Re: Petition of VCP FX CT, LLC for Declaratory Ruling for the Construction, Operation, and Maintenance of a 1.5 MW AC Roof-Mounted Solar Photovoltaic Electric Generating Facility at FedEx Distribution Center, 49 FedEx Drive, Middletown, Connecticut

Petition No. 1550
VCP FX CT, LLC d/b/a Verogy
Fed Ex Distribution Center, 49 FedEx Drive
Middletown, Connecticut
Responses to Interrogatories
Set One
January 9, 2023

Proposed Building Section
(Looking East)
January 2023

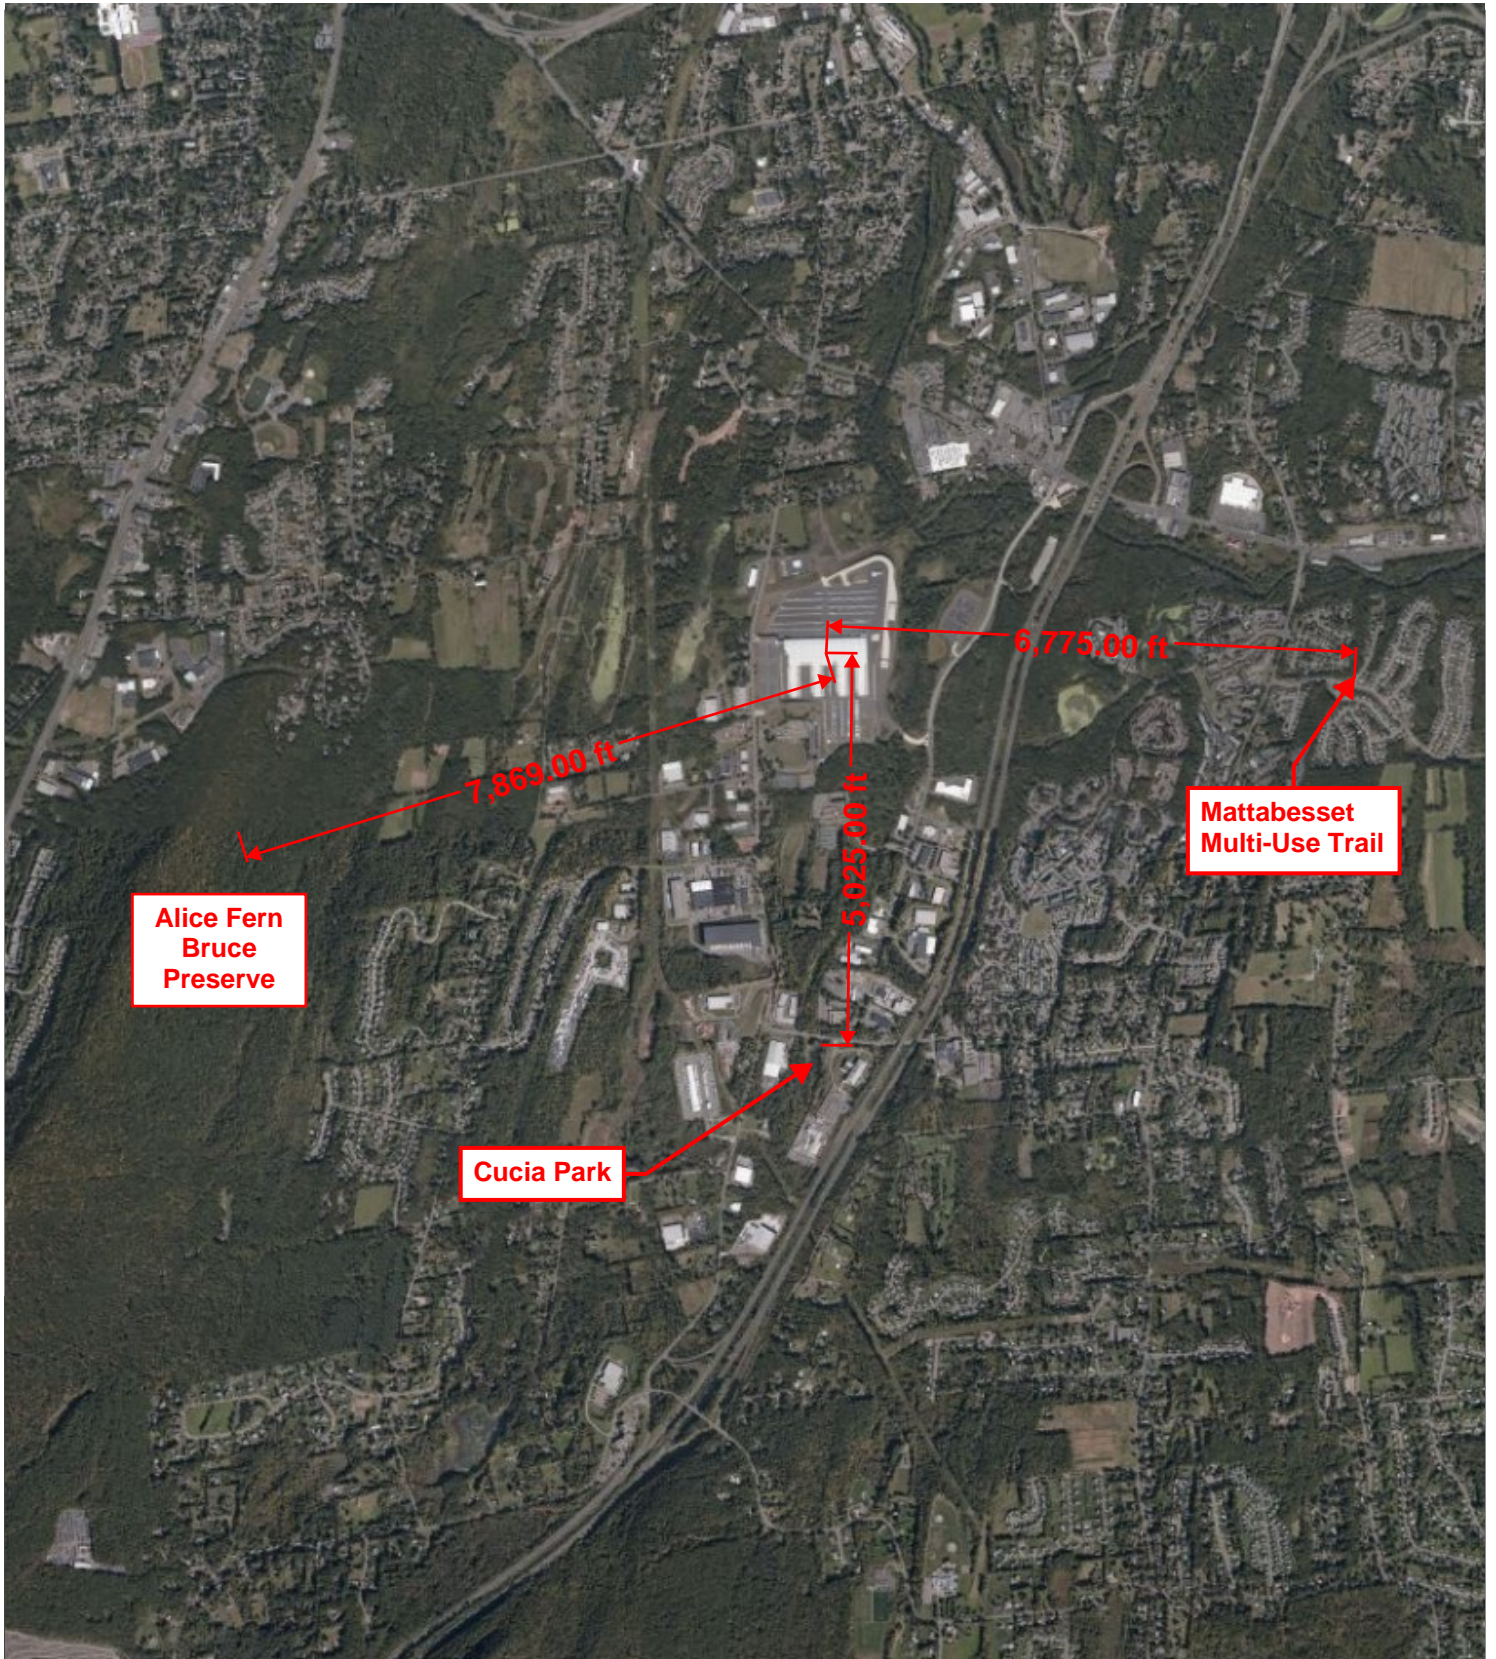
12. Provide a side profile drawing to depict the solar panel angle with the horizontal, and the maximum and minimum heights of the arrays above the roofline.

See Exhibit 1 for a side profile drawing showing the solar panel angle above the roofline. The panels are in portrait orientation facing south and are flush mounted to the building at the same slope as the roof. The top face of the panels will be approximately 6 inches off the top of the roof. The roof is approximately 71 feet high on the southern side and approximately 79' high on the northern side.

Recreational Areas
January 2023

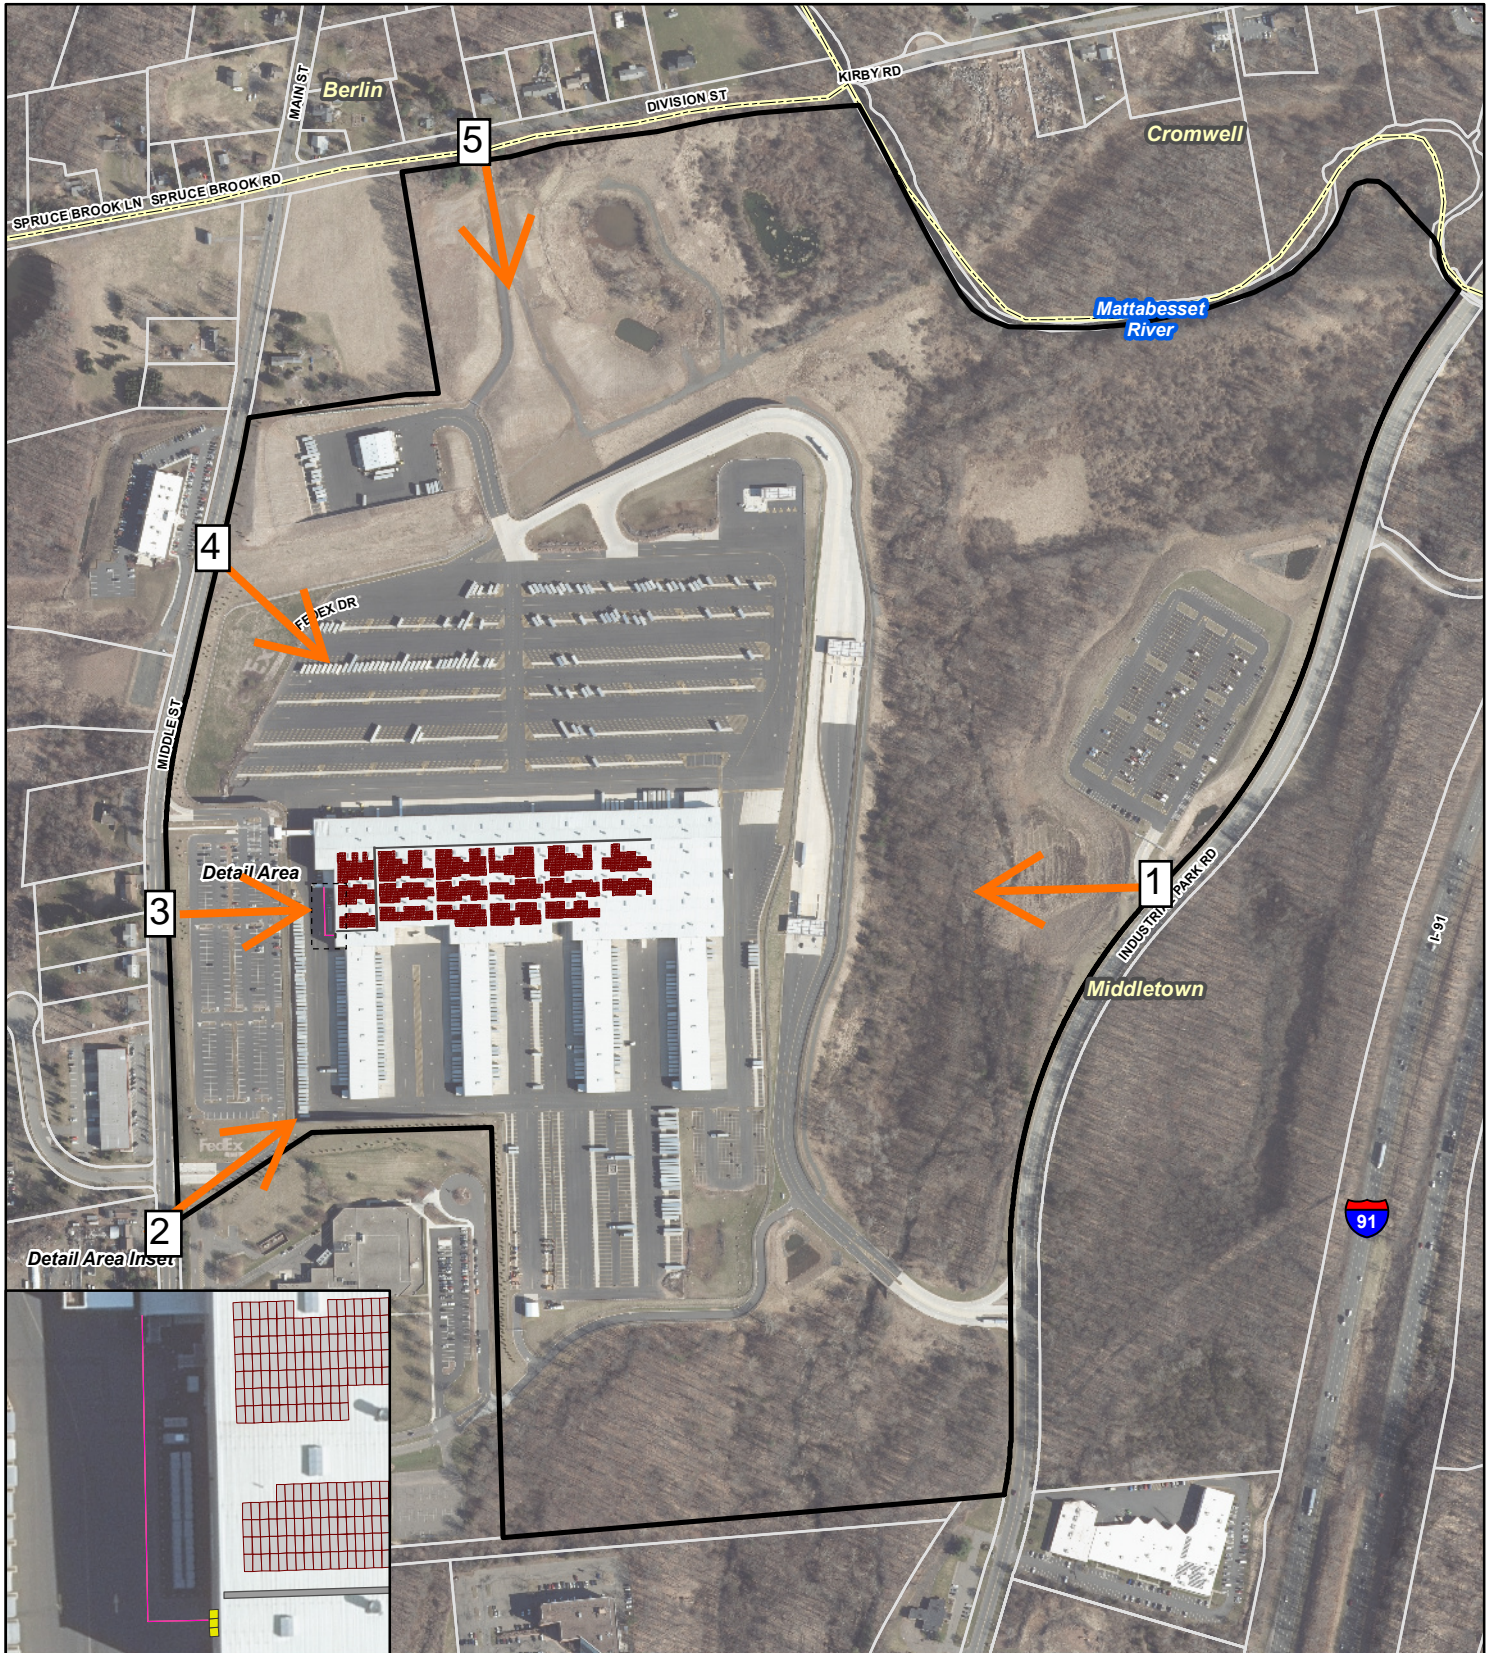
- 21. Referencing page 20 of the Petition, please provide a map showing the referenced recreational areas and the distance of each from the site.**

See Exhibit 2
